**ORANGE COUNTY WATER DISTRICT
18700 Ward Street
Fountain Valley, California 92708**

**ADDENDUM NO. 1
TO
CONTRACT DOCUMENTS
FOR
RESEARCH & DEVELOPMENT LABORATORY BUILDING FLOORING SERVICES
CONTRACT NO. FV-2026-1
7/13/2026**

RESEARCH & DEVELOPMENT LABORATORY FLOOR PLAN

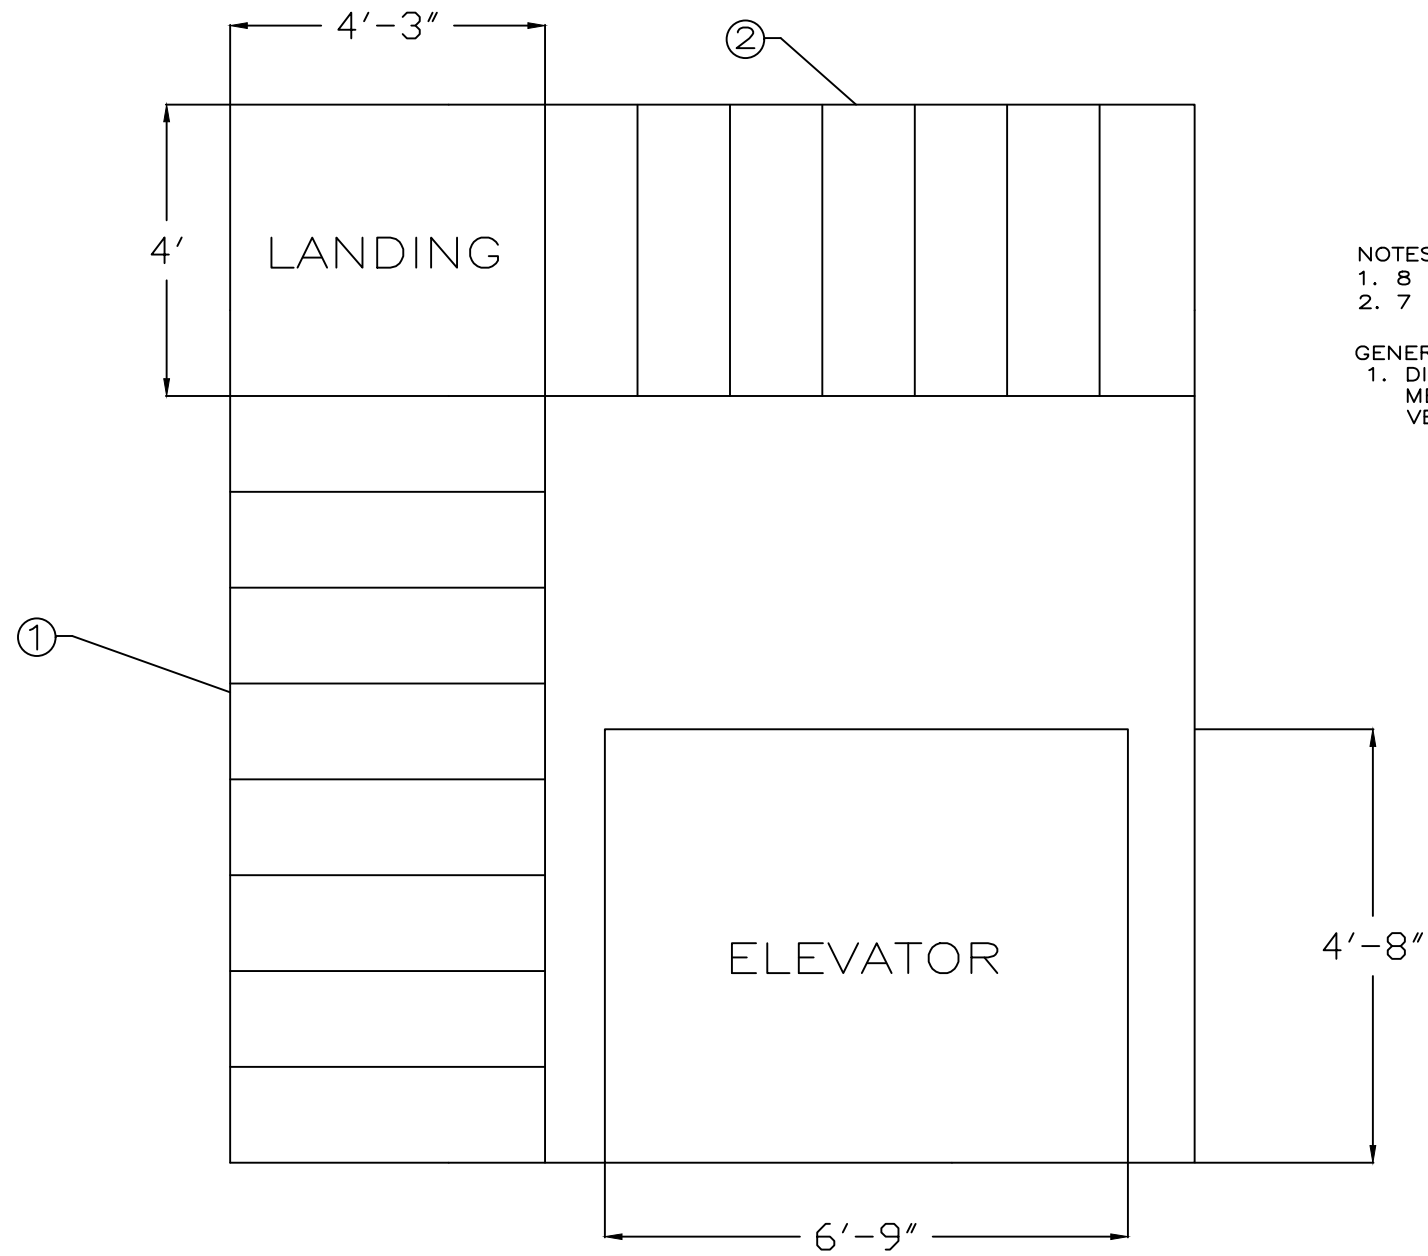
- a. ADD "Laboratory" and "Office" to each room missing a designation in the Second Floor Research & Development Laboratory Floor Plan (Attachment A of this Addendum).
- b. ADD Emergency Stairwell drawing to Research & Development Laboratory Floor Plan (Attachment A of this Addendum).
- c. REMOVE File Room as part of scope (Attachment A of this Addendum).

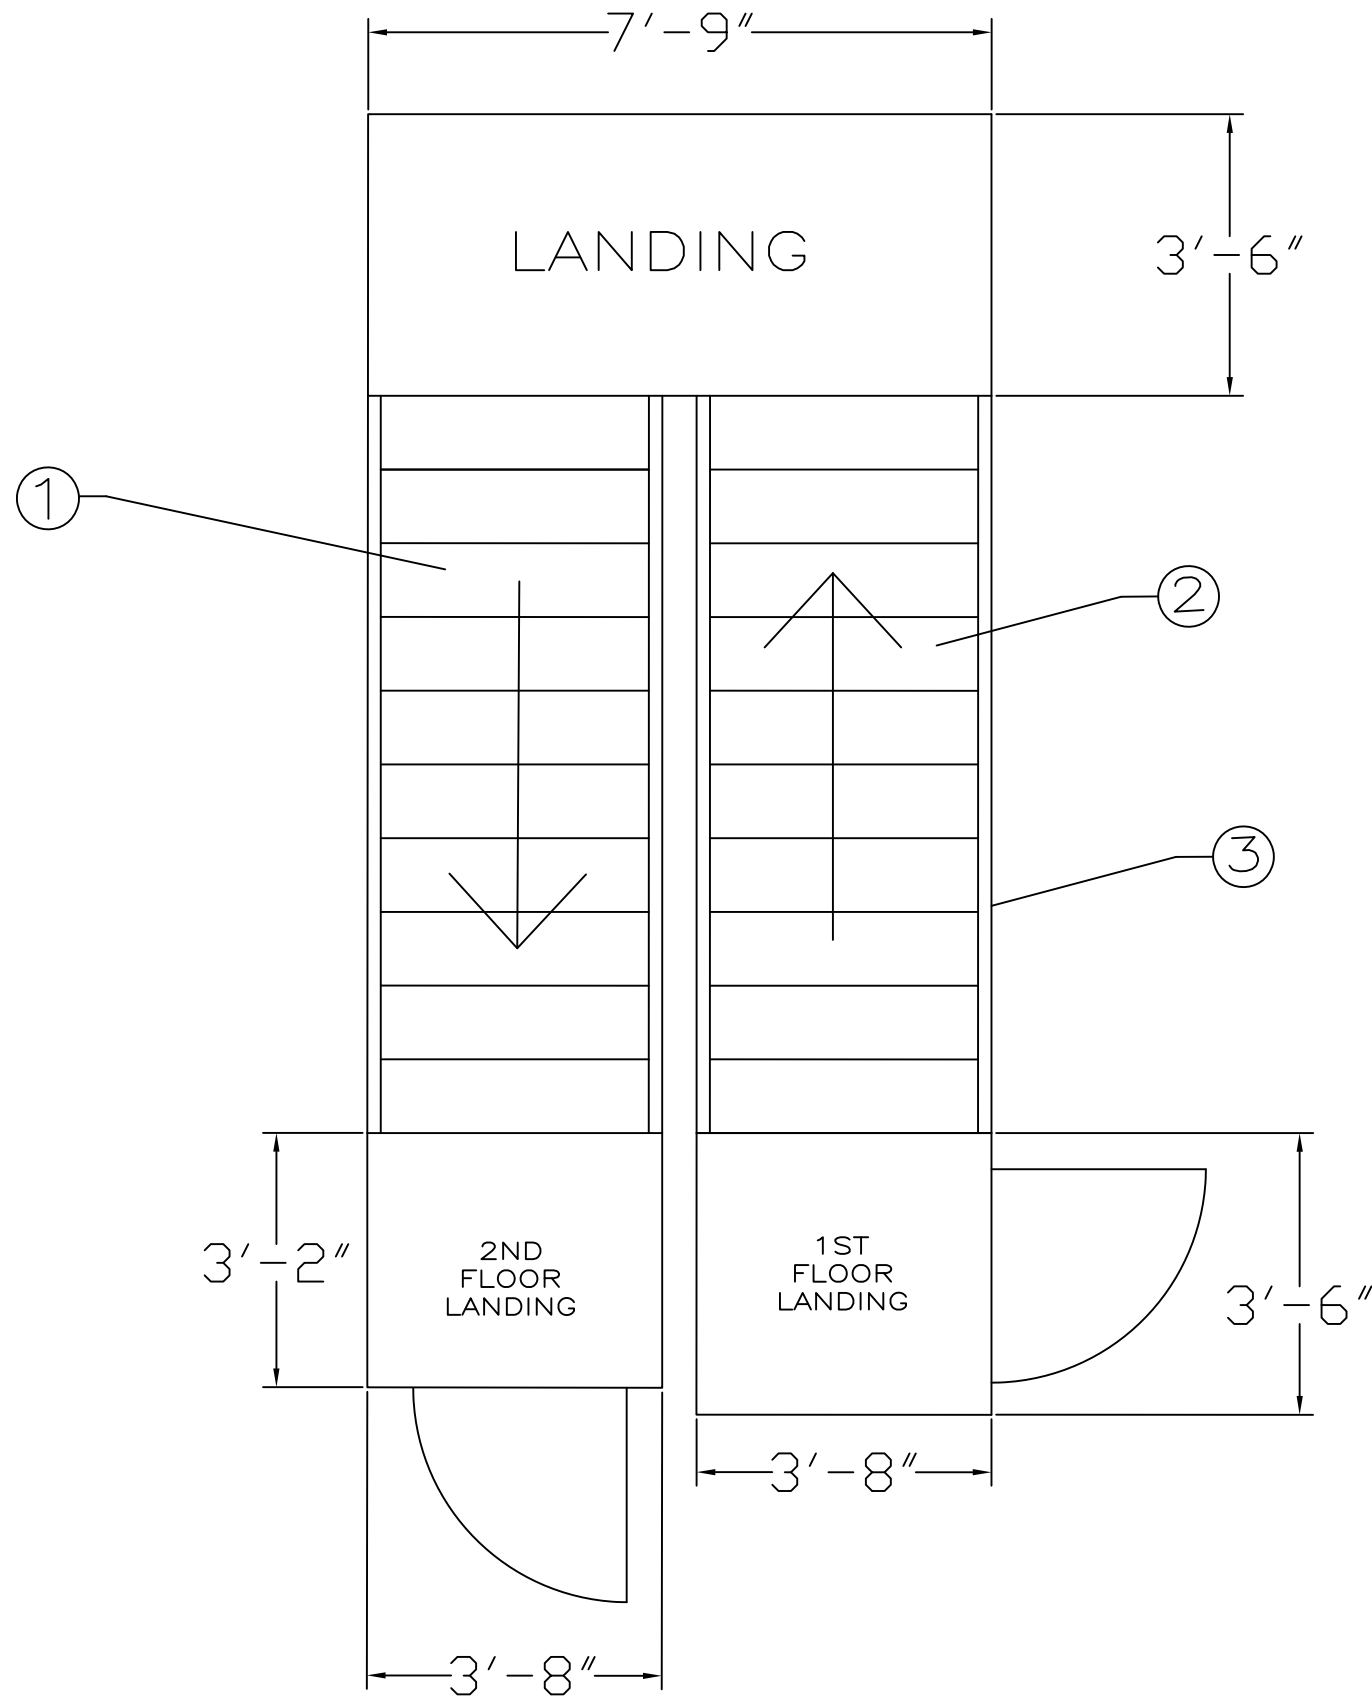
6	Emergency Stairwell Drawings Please provide drawings for the emergency stairwell.	See attached drawings. Contractor shall confirm all dimensions provided.
7	What is the estimated cost of this project?	Per the posted project planroom, Engineer's estimate is \$130,000.
8	Is there an addendum issued, can I get a copy?	Yes, it will be posted on the OCWD R&D Lab Building Flooring Service project page
9	Can we submit a bid under License B utilizing a C-15 subcontractor, or whether the bid must be submitted directly by a contractor holding the C-15 and Gen B licenses?	A perspective bidder holding a Class B license can utilize a Sub-Contractor holding a Class C-15 license. A perspective bidding holding a Class B and/or Class C-15 license may submit a bid.
10	Would it possible to reduce the liquidated damages amount to \$500 per day?	Yes, the liquidated damages can be reduced to \$500 per day.
